# **Mobile Intel® Celeron® Processor at 466 MHz, 433 MHz, 400 MHz, 366 MHz, 333 MHz, 300 MHz, and 266 MHz Specification Update**

Release Date: May 2002

Order Number: 244444-032

**Figure 1. An Example of Microcontroller Driven Thermal Management**

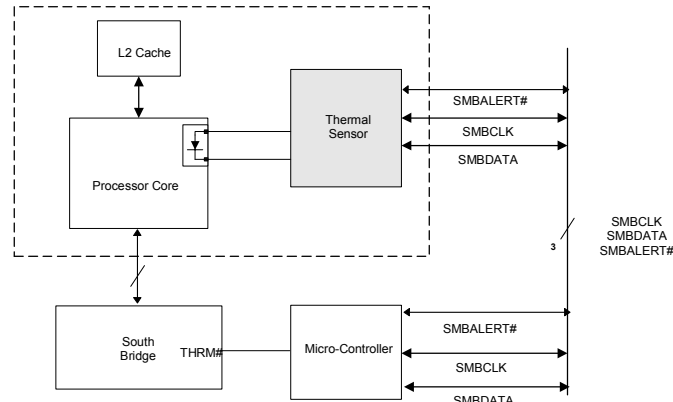
**Problem:** The Intel Celeron Processor Mobile Module has a thermal sensor that monitors the processor core's temperature. Please note that desktop systems could have a similar thermal device. The thermal sensor asserts SMBALERT# if the processor temperature exceeds the temperature limits set in the Alarm Threshold Registers ( $T_{HIGH}$ ,  $T_{LOW}$ ). It also sets the corresponding Status Register bits to identify the cause of the interrupt. Figure 1 gives one example of the how the SMBALERT# signal could be used in a system.

**Figure 2. Workaround Flowchart: SMBALERT#-Driven System**

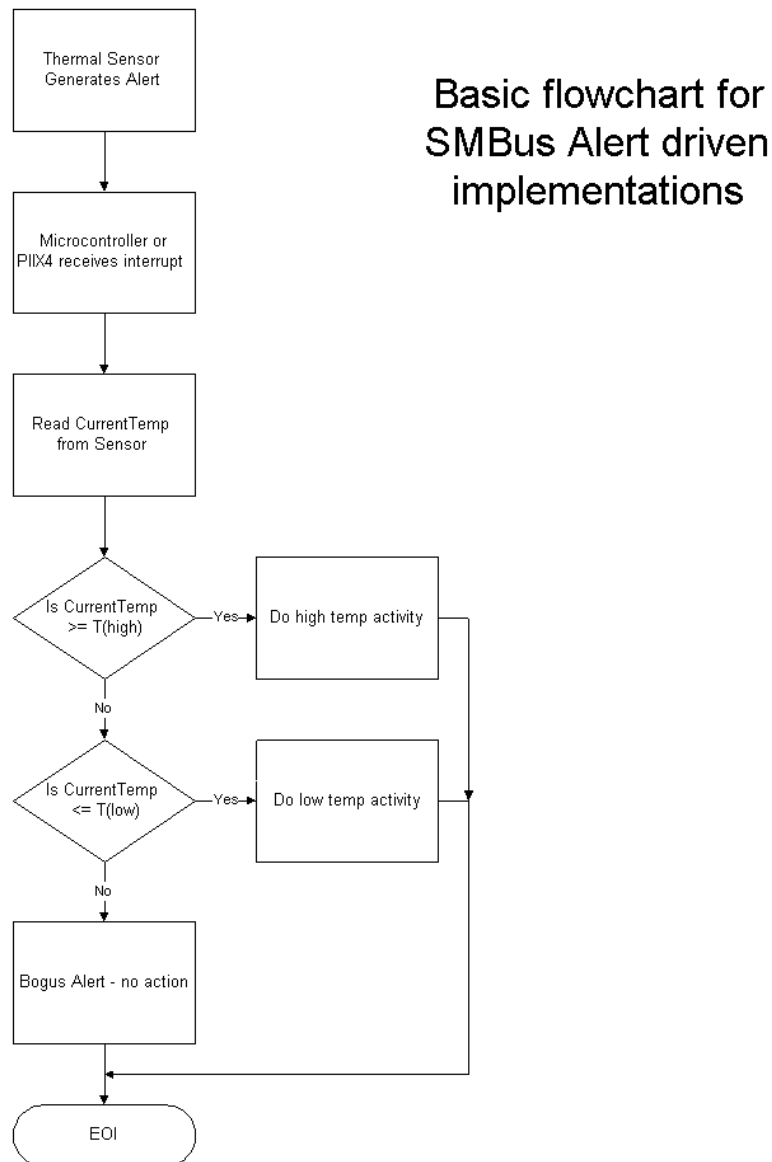
**Implication:** There is no system impact from this erratum if temperature polling is used for processor thermal management. If the SMBALERT# interrupt is employed to manage processor thermal sensing, then servicing the false interrupt may result in premature system action depending on the software and hardware implementations used. The rate of the false interrupts is less than the auto-convert rate of the thermal sensor.

**Workaround:** Three different (mutually exclusive) workarounds are possible:

1. Before servicing an interrupt from the thermal sensor, read and compare the processor thermal reading with the threshold limits ( $T_{HIGH}$  or  $T_{LOW}$ ). Figures 2 and 3 provide basic flowcharts for the implementation of this workaround in an interrupt driven system.
2. If the firmware implemented polls the Status Register only, then before taking any action, re-read the temperature register and do a comparison with the alarm threshold limits ( $T_{HIGH}$  or  $T_{LOW}$ ) to determine if the value is actually still within the temperature window.
3. Use a temperature polling scheme to monitor the processor temperature.
